### NOTICE OF MEETING - PLANNING APPLICATIONS COMMITTEE 12 AUGUST 2026

| 3. | PL/26/0415 (REM) - STATION HILL Decision | ABBEY | 7 - 104 |

| <b>Title</b>                           | <b>PLANNING APPLICATION REPORT</b>

Figure 5.2: Bin and Core Plan

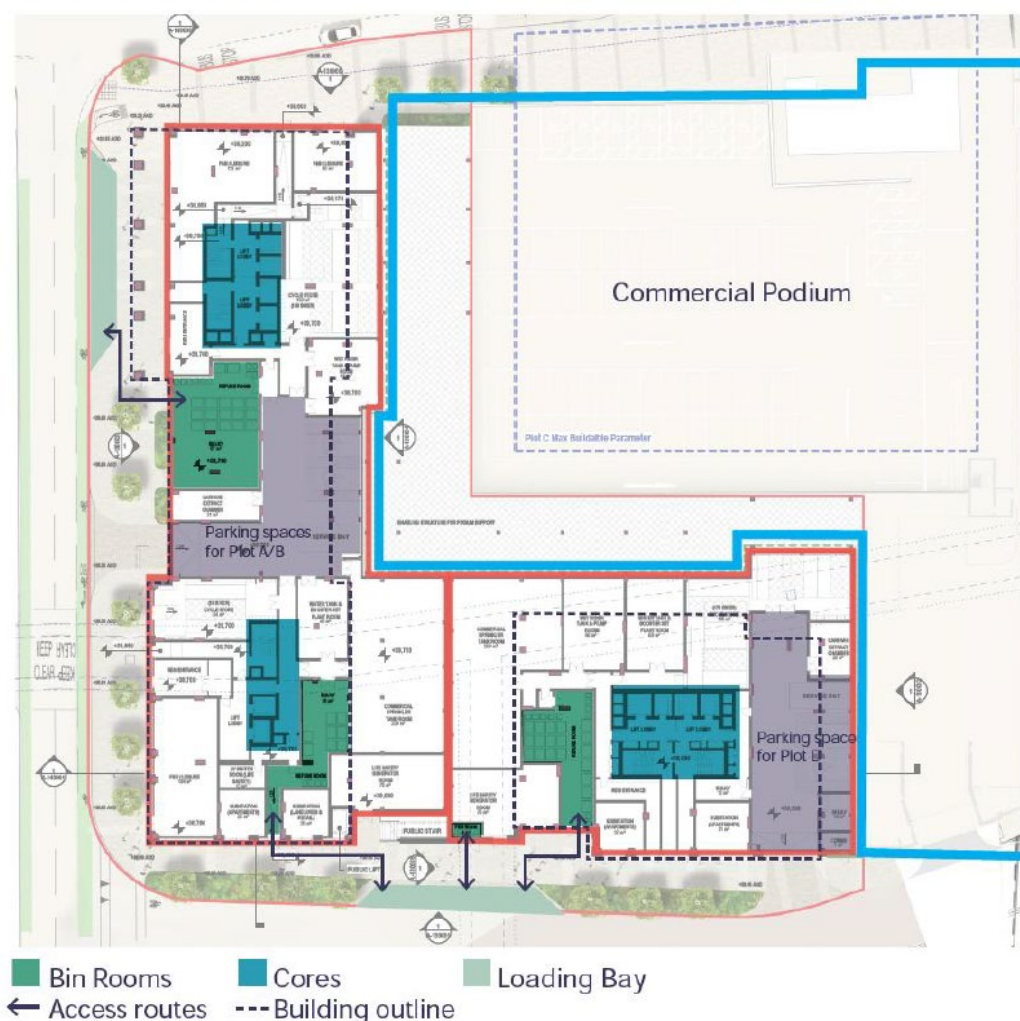
- 6.183 This results in the bin stores being necessarily deep in terms of their footprint (it would not be desirable for them to occupy more of a frontage than is strictly necessary) and also constrains their size to a degree which limits the amount of waste which can be stored at any one time. As to the case in the town centre this will not fit with the Council's standard collection arrangements and will necessitate a private collection. The submitted details confirm that the storage is designed around three collections per week for all waste and which reflects the approach already undertaken with the 598 flats constructed at Plots E and F ("Ebb" and "Flow") within the wider Station Hill site.

Image 1 – Diagram illustrating desire line

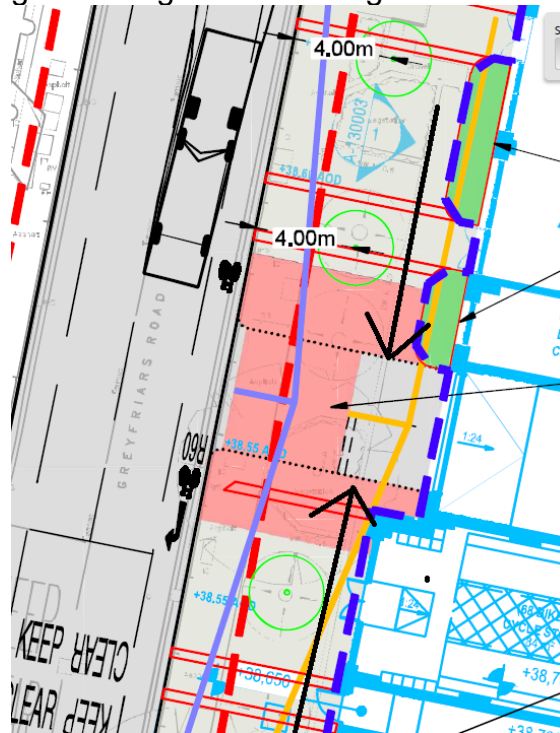
Visibility splays for the vehicle accesses have been illustrated and the Greyfriars Road splay is deemed acceptable. A cycle visibility splay has been illustrated at the access onto Greyfriars Road but the give way line has been positioned along the desire line for pedestrians and cyclists. The applicant has stated that the landscaping around the access onto Greyfriars Road pushes cyclists away from building edge and the raised table now provides a desire line for pedestrians away from the give way line. However, as Image 1 below illustrates by way of the black arrows there is still a desire line for

pedestrians and cyclists right adjacent to the building line especially as a cycle store and residential entrances are located directly south of the vehicle access.

As had been previously discussed and agreed at the pre-application meeting some form of increased physical measure is required to effectively direct pedestrians and cyclists away from the building edge to ensure that adequate sightlines are provided. It had been agreed that low level landscaping would be provided similar to what has been proposed to the north but a larger area on both sides of the access but this has not been illustrated on the submitted plans. A proposal similar to that provided at Image 2 below must be incorporated into the scheme design or the give way line would need to be set back into the site and the building line adjusted to facilitate the visibility splay.
